HARTING Pushing Performance	HARTING Product Change Notification	PCN
--	--	------------

PCN/23/013/C+N-US

Product Range: Board Connectors / har-flex

Title: Har-flex pin length optimization

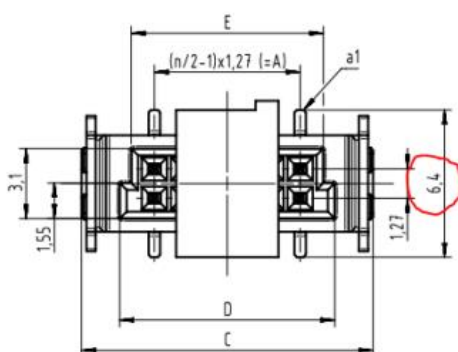
To improve the automatic optical inspection process at customer side, we will shorten our contacts. In the past it could happen that the pin toes were overhanging, this will be prevented in future. The new dimension allows a detectable soldering meniscus, which leads to a better checkability in the PCB production.

The above shown dimension will change from 6.4 mm to 6.2 mm with a tolerance of $\pm 0,2$ mm and allows a nominal solder meniscus of 0.2 mm.

Old pick and place pad:

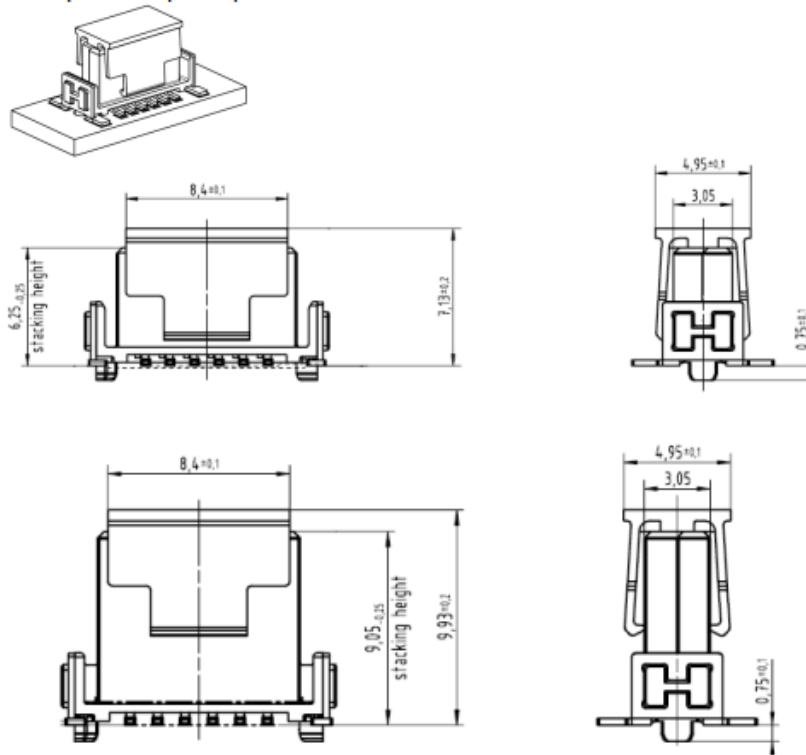
Additionally, we will change the pick and place pads of the named connectors with 12 or more pins. The bigger pads allow to use bigger standard nozzles and therefore higher placing speeds.
